MILITARY SPECIFICATION

LIGHT, SIGNAL, HAND HELD, AIRCRAFT, TYPE MA-1

This amendment forms a part of Military Specification MIL-L-7569A (USAF) dated 11 August 1969.

LIGHT ASSEMBLY
FIGURE 1A
Page 2 of 2

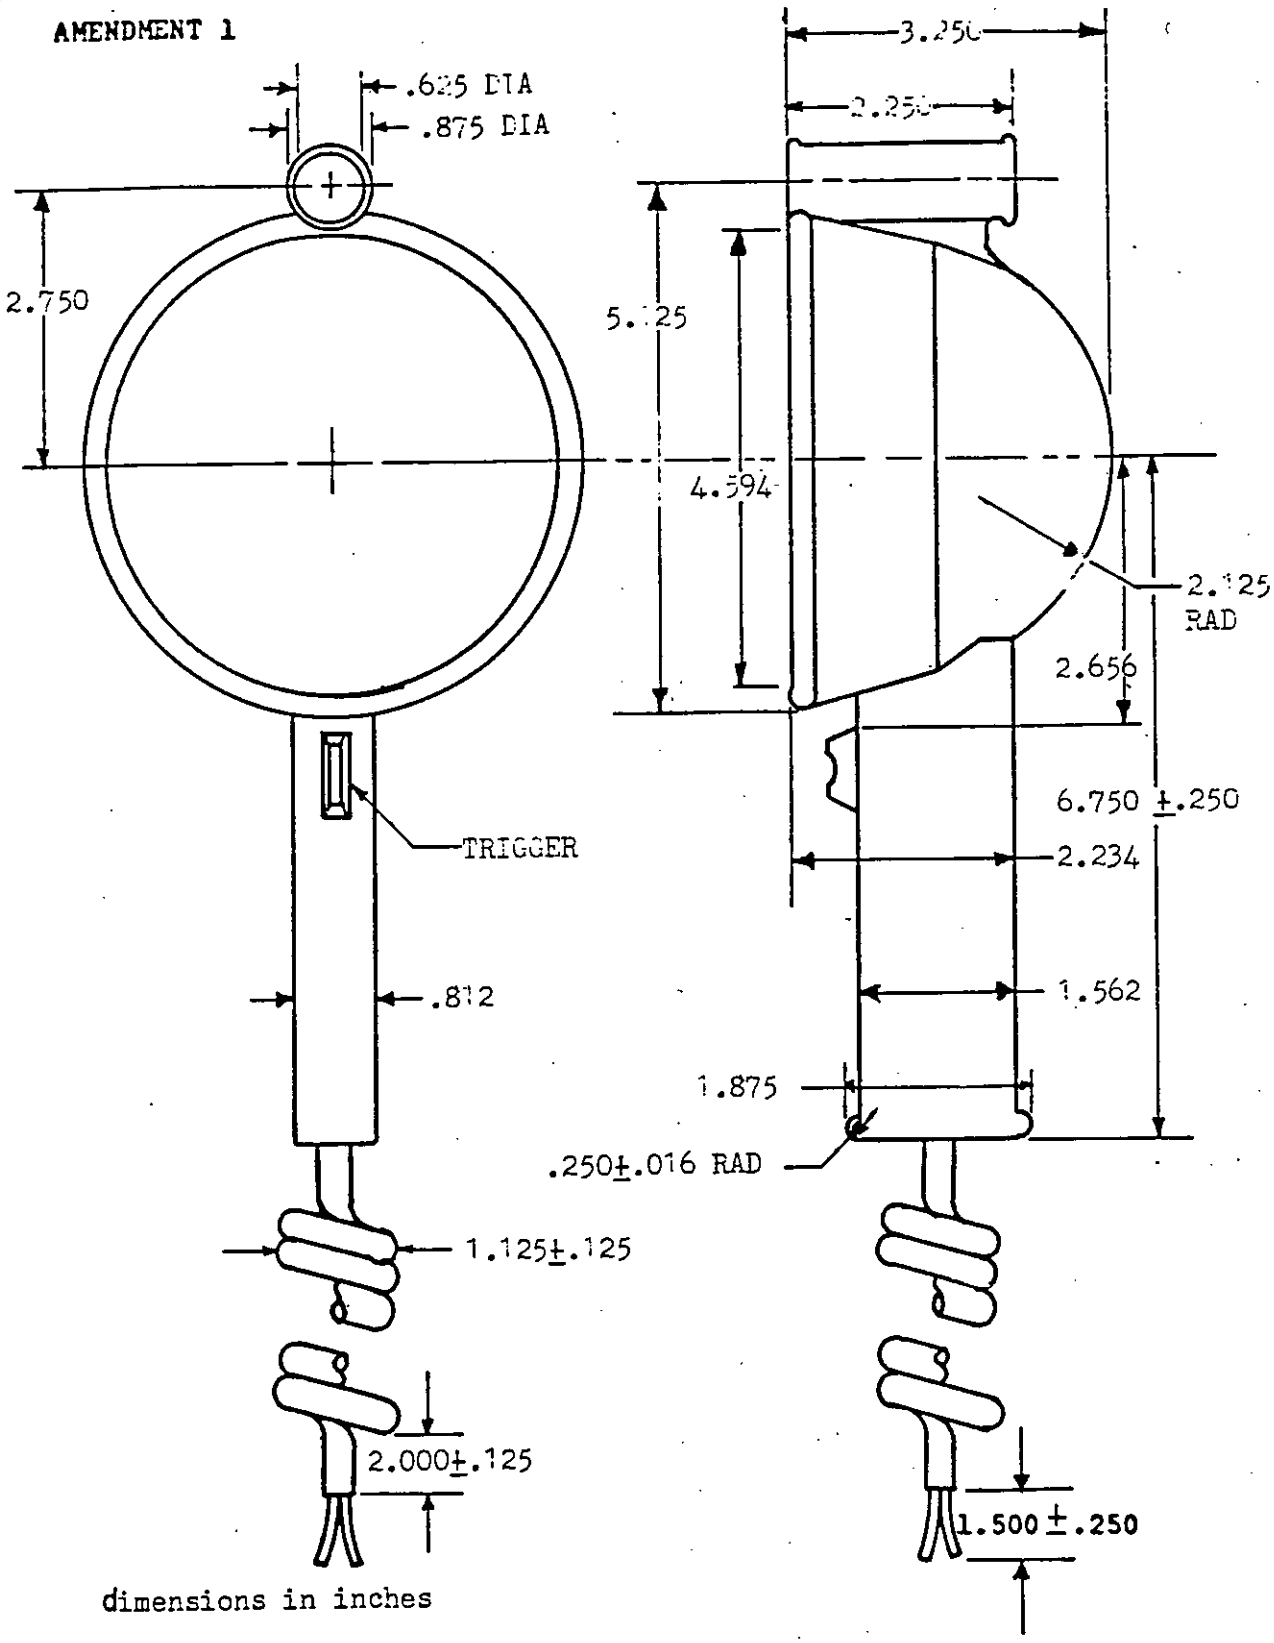
Page 2, paragraph 3.5, in the fifth sentence delete reference to "MS28925" and substitute "Figure 1A".

Page 3, paragraph 3.8, delete the first sentence and substitute the following: "The dimensions shall conform to those shown in Figure 1A".

Page 4, delete "Figure 1" and substitute "Figure 1A".
